Recommendation: PBN Instrument Procedure Design (STAR Speeds)

Recommendation: The PARC Navigation Working Group recommends the PARC Steering Group support a change to FAA Order 8260.58A, Table 1-2-2, Note 3, to read; "250 above 14,000 feet MSL".

Figure 2

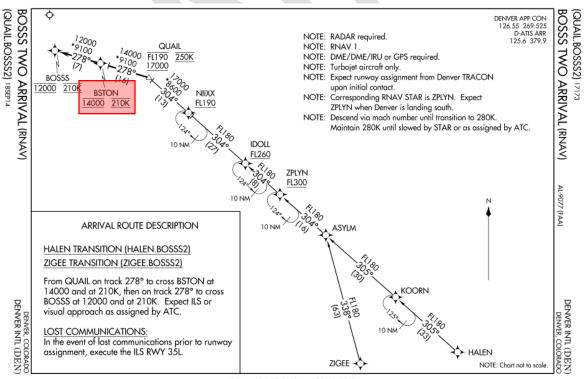
With this in mind, since Order 8260.3D permits use of a minimum airspeed as low as 210 KIAS at and below 14,000 FT MSL, there is no apparent reason why a STAR cannot use a minimum airspeed as low as 210 KIAS at the same altitudes when operationally necessary (see the STAR at Figure 2 below). Updating the STAR procedure design criteria to permit use of a minimum airspeed of 210 KIAS will offer more flexibility in STAR design and better optimize STAR paths, while also eliminating the need to justify a procedure design waiver when the STAR requires an airspeed below 250 KIAS as an operational necessity.
